The Commission has issued the enclosed Amendments Nos. 42, 39 and 16 to Facility Licenses Nos. DPR-33, DPR-52 and DPR-68 for the Browns Ferry Nuclear Plant Units Nos. 1, 2 and 3. These amendments consist of changes to the Technical Specifications in response to your request of December 2, 1977, supplemented by letters dated December 20, 1977, May 24, May 26, June 30, August 2, August 10, and September 1, 1978.

These amendments authorize you to increase the storage capacity of each of the Browns Ferry spent fuel pools from 1080 to 3471 fuel assemblies.

ENVIRONMENTAL IMPACT APPRAISAL
BY THE OFFICE OF NUCLEAR REACTOR REGULATION
RELATING TO AN INCREASE IN STORAGE CAPACITY OF
THE SPENT FUEL STORAGE POOLS
TENNESSEE VALLEY AUTHORITY
BROWNS FERRY NUCLEAR PLANT UNITS NOS. 1, 2 AND 3
DOCKETS NOS. 50-259, 50-260 AND 50-296

STORAGE ARRANGEMENT
 BFPN - UNIT 1
 FIGURE 1

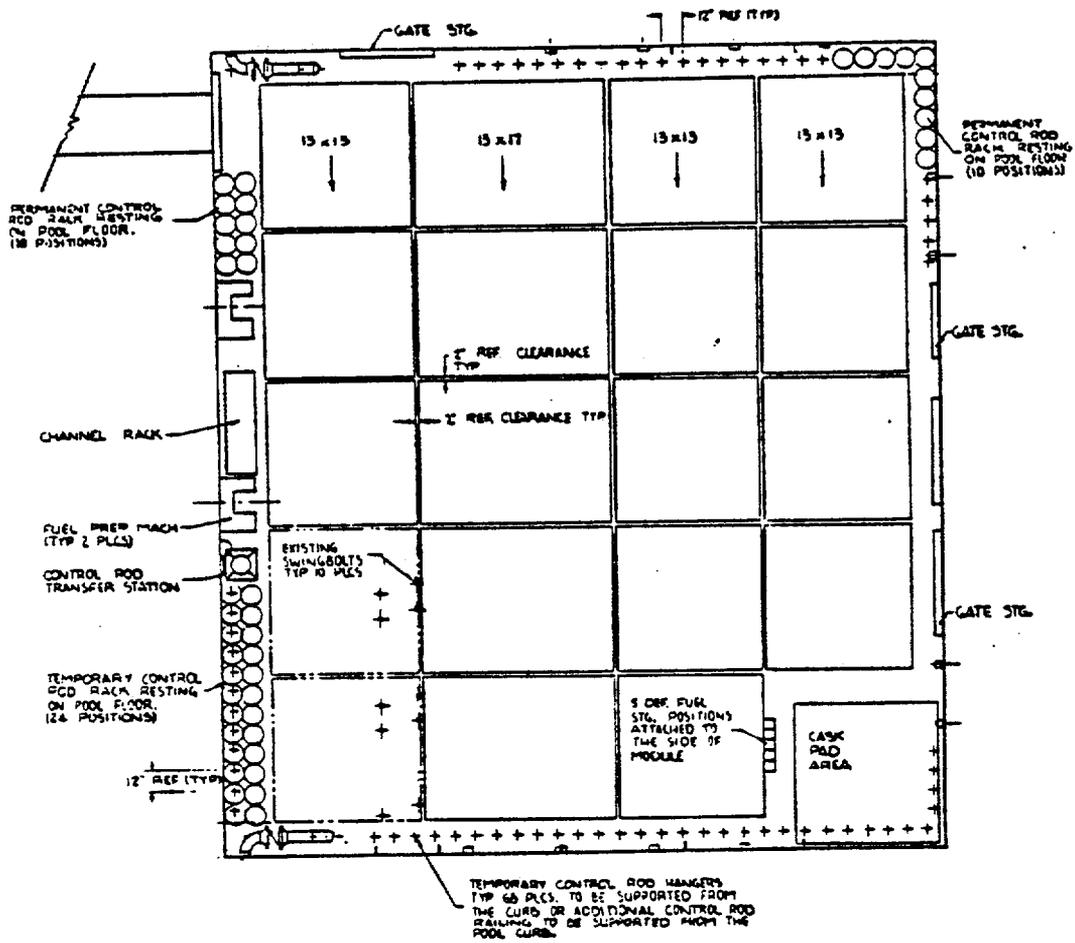
The arrangement of the high density fuel storage system for the spent fuel pools is shown in Figures 1, 2 and 3. The relatively small quantities of material resources being committed would not significantly foreclose the alternatives with respect to other licensing actions designed to ameliorate a possible shortage of spent fuel storage capacity. The principal material resources that will be consumed by the proposed modification together with estimated annual domestic consumption are indicated below.

Fuel Storage	<u>3471</u>
Defective Fuel Storage	<u>5</u>
Control Rod Storage	
Perm. Racks	20
Temp. Rack	24
Temp. Hangers	<u>69</u>
	<u>113</u>

FIGURE 2.

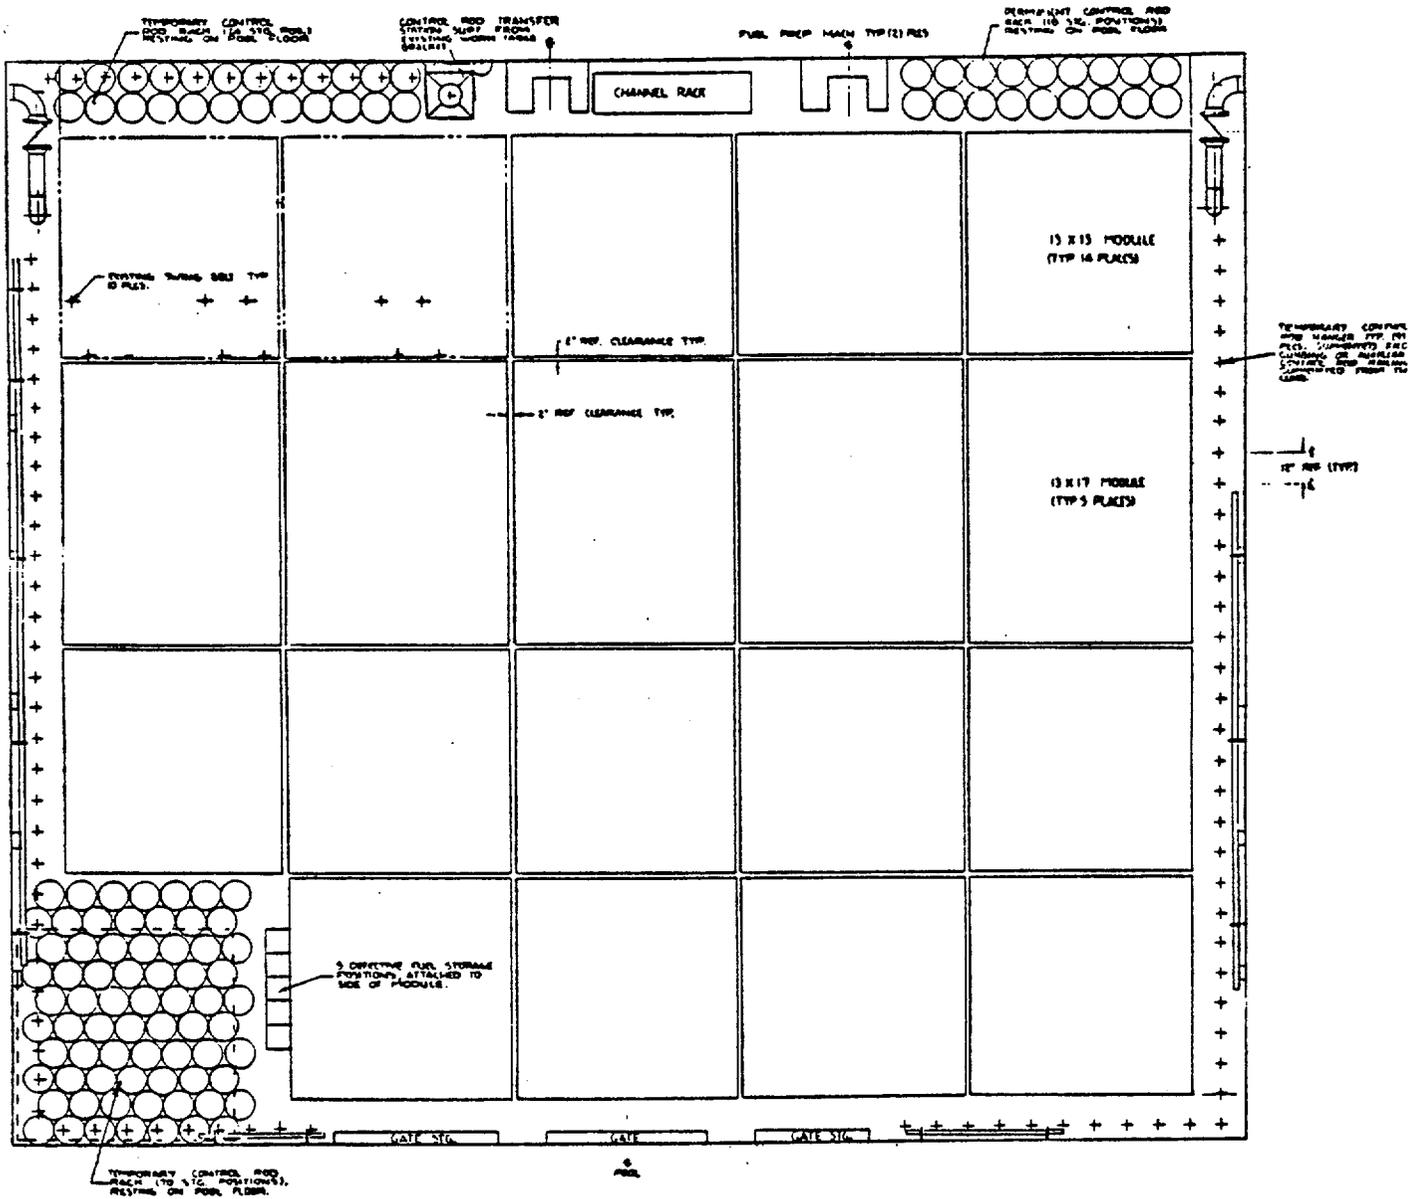
Fuel Storage	<u>3471</u>
Defective Fuel Storage	<u>5</u>
Control Rod Storage	
Perm. Racks	20
Temp. Rack	24
Temp. Hangers	68
	<u>112</u>
